Record of Decision

NYSEG - Central Ave. Mechanicville MGP Site

Mechanicville, Saratoga County, New York
Site Number 5-46-033

March 2006

FIGURE 4

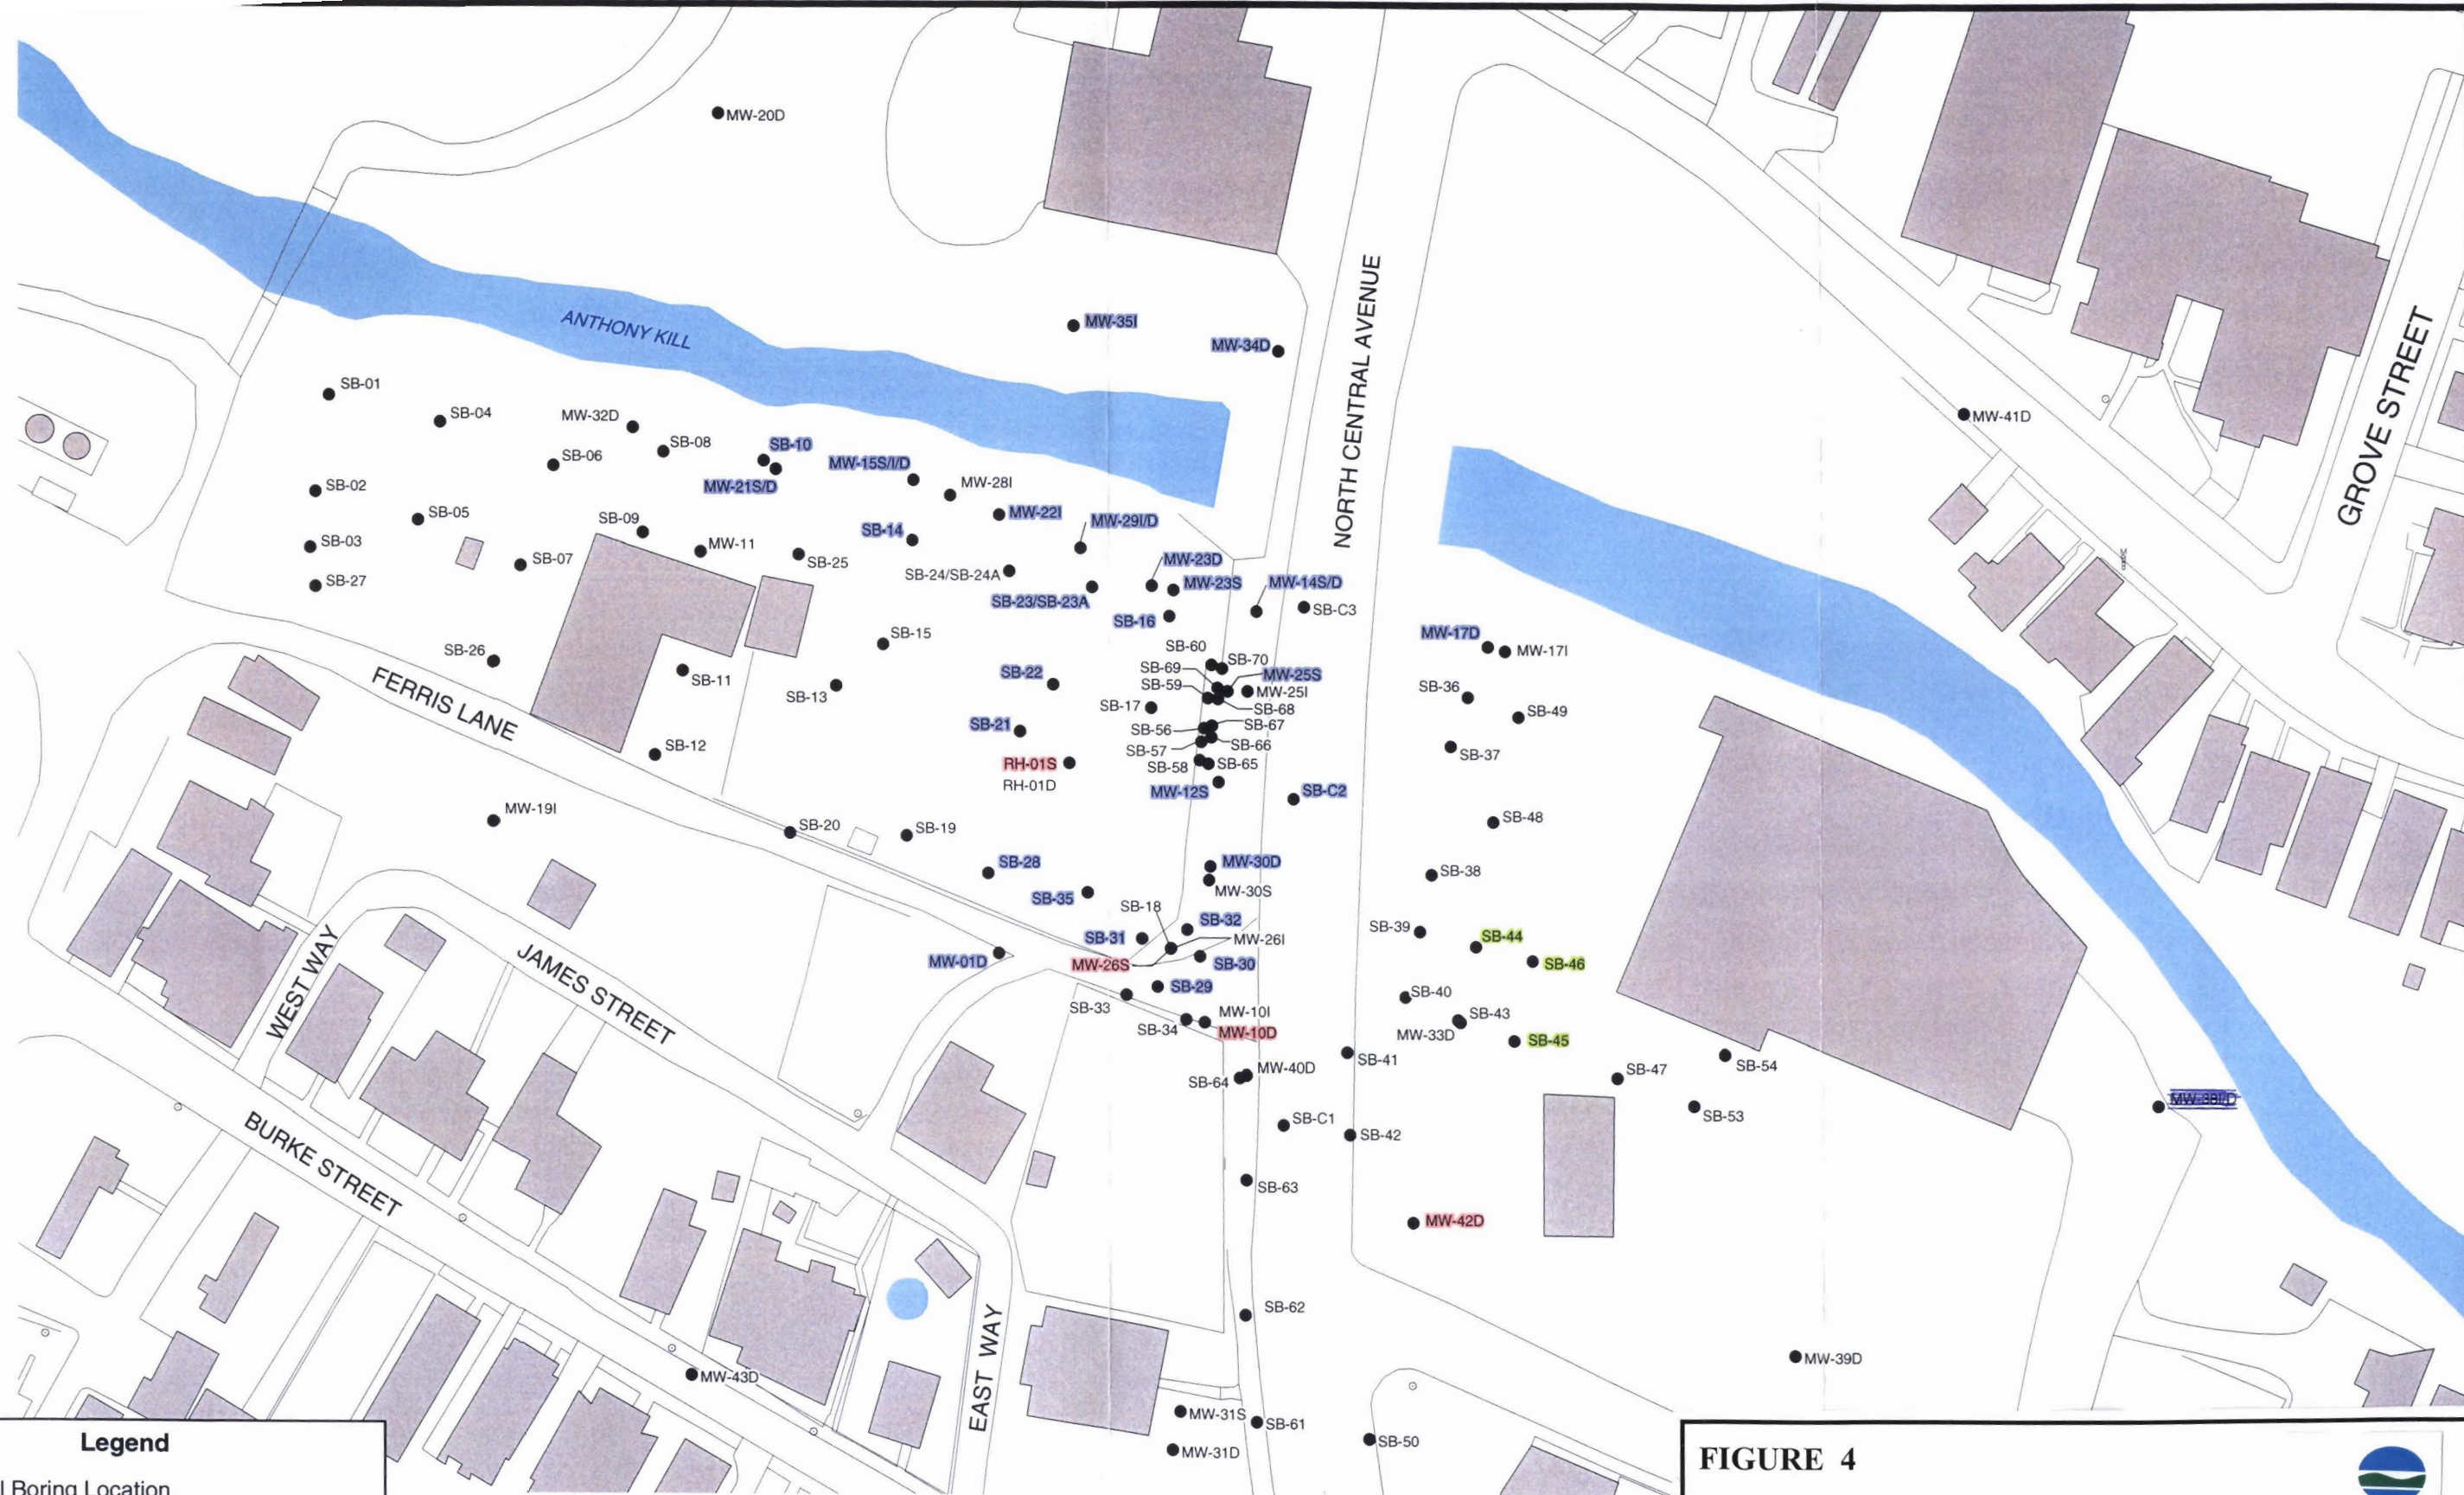
COMMENT 6: Did you do test borings to determine the southern extent of contamination?

RESPONSE 6: Yes, as shown on Figure 4, borings were drilled south of the site to determine the southern extent of contamination.

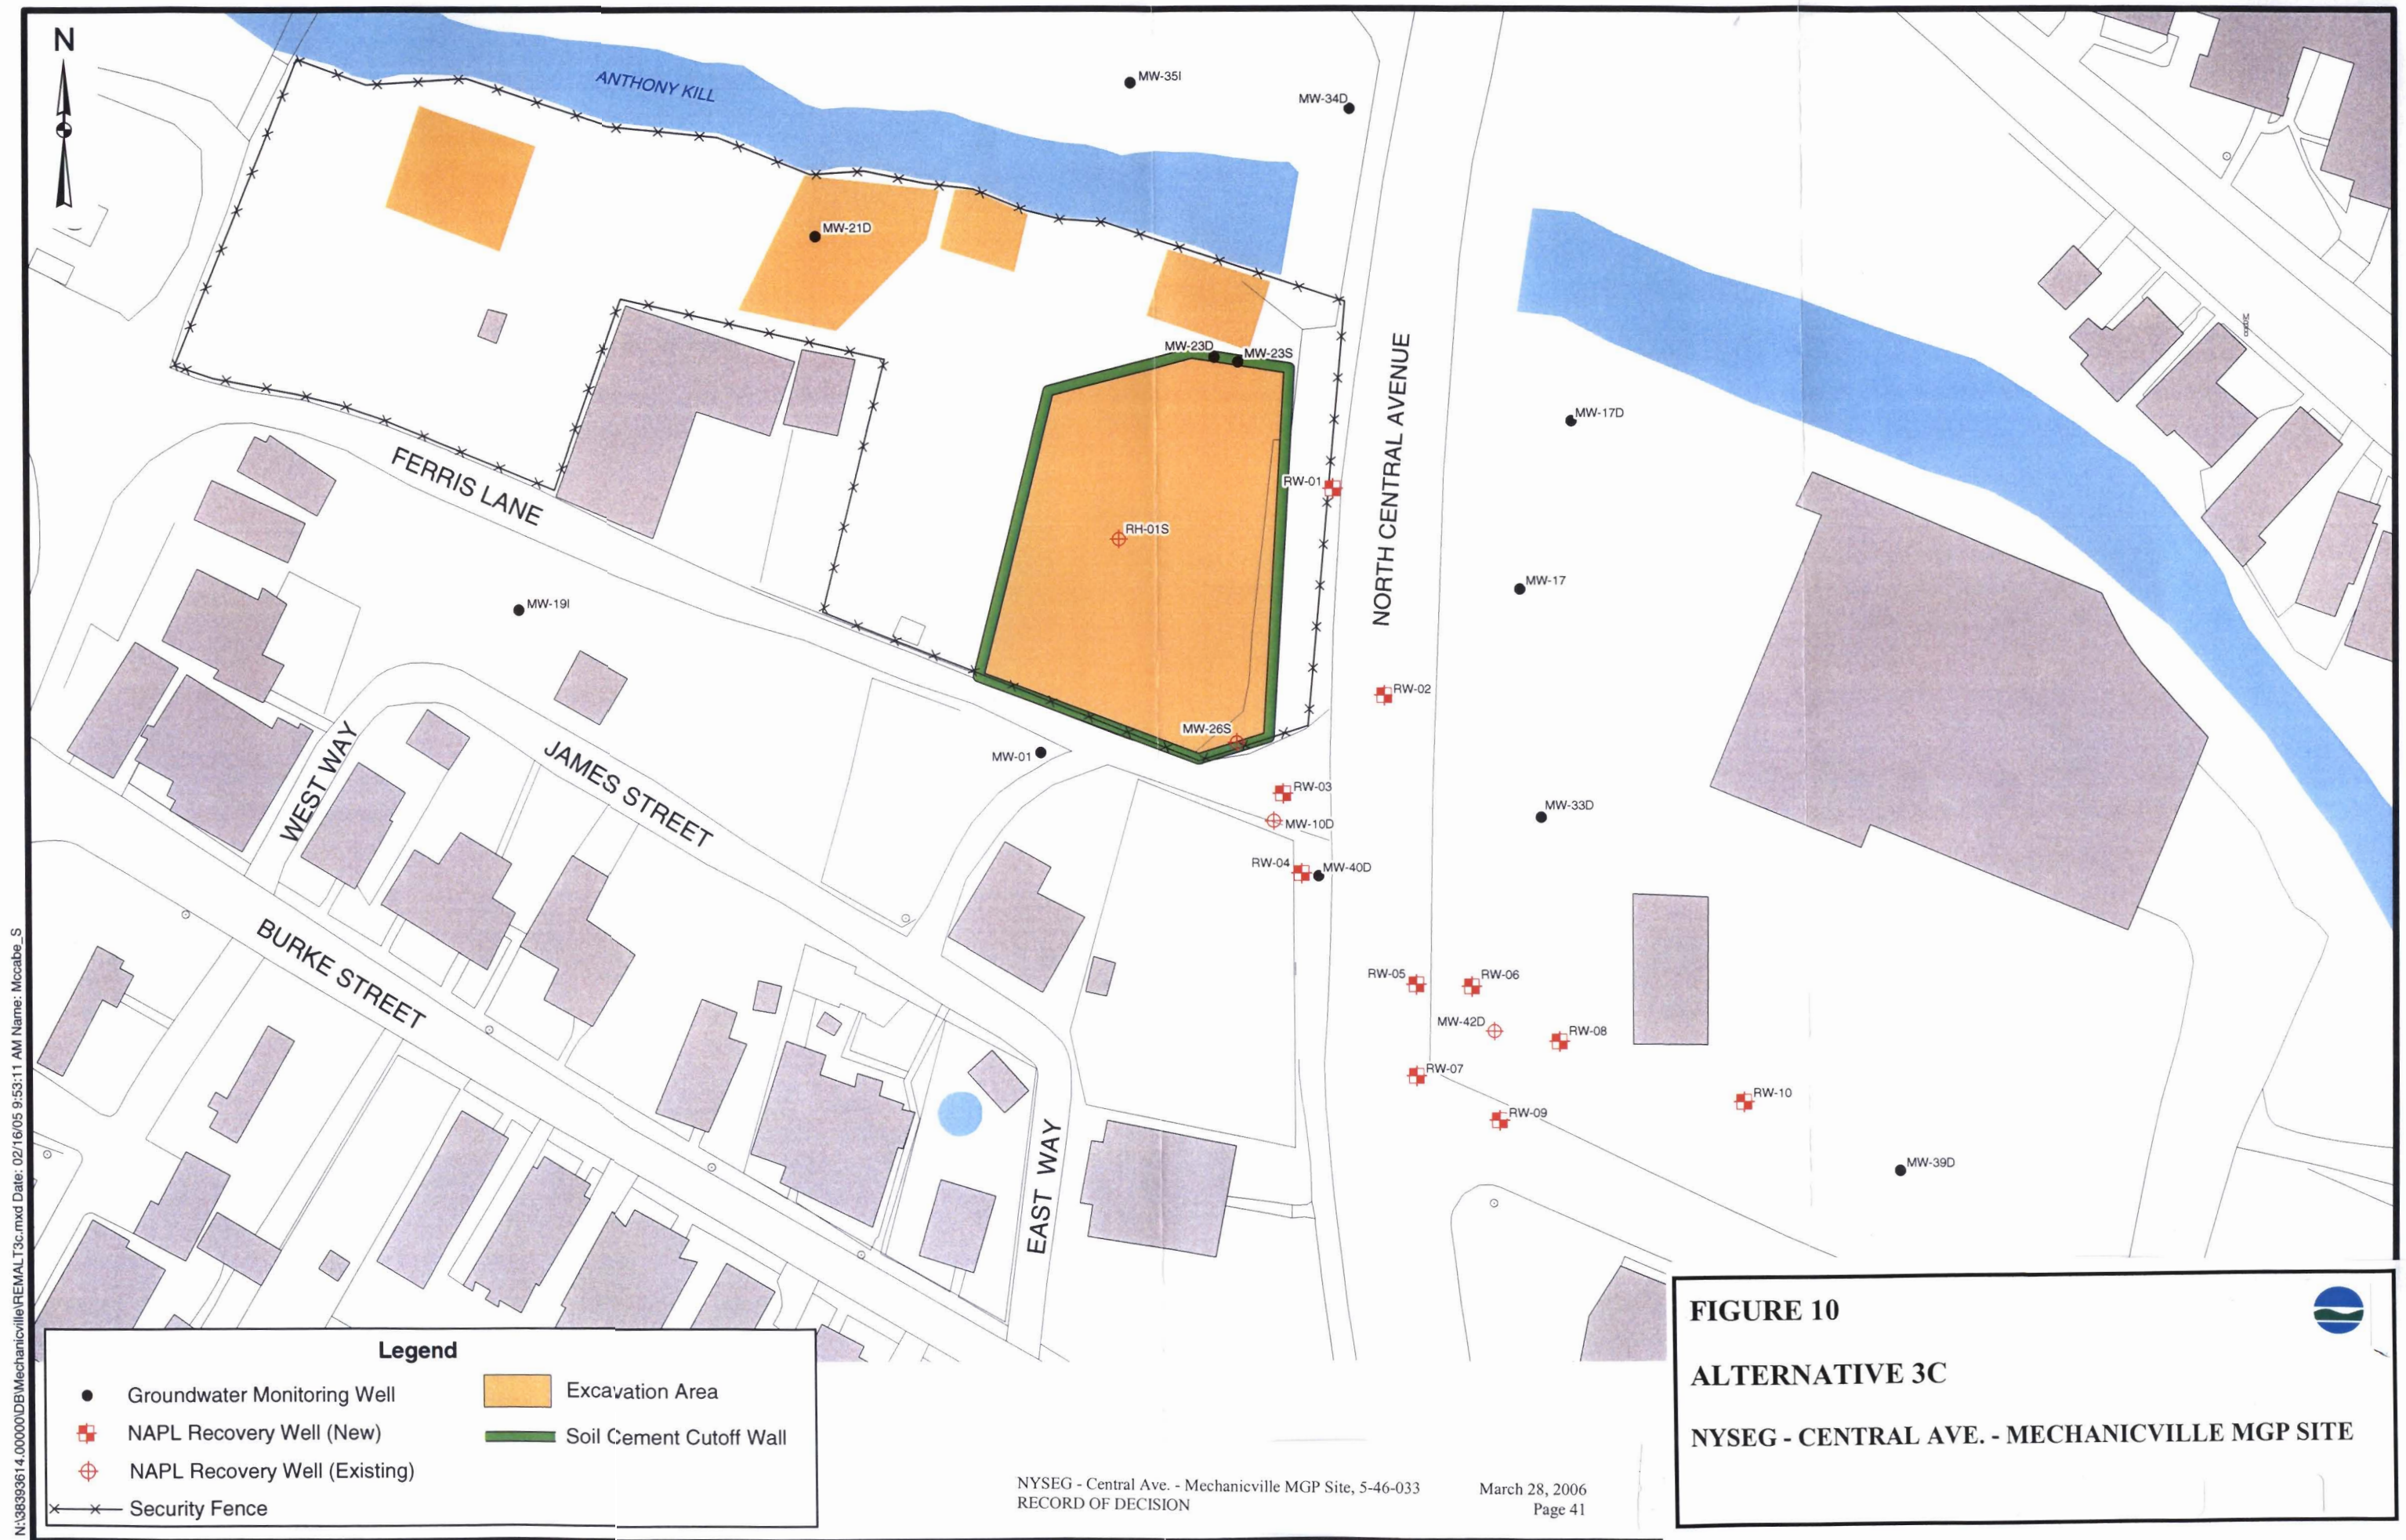
COMMENT 18: Is there a plan to place a recovery well near the Getty Station - the southern limit of contamination?

RESPONSE 18: NAPL is being recovered currently from existing monitoring well MW-42D on the Getty Station property. The NYSDEC therefore considers this area to be a good candidate for recovery well(s) as shown on Figure 10. A plan will be developed following the ROD which will more closely examine where to place recovery wells.
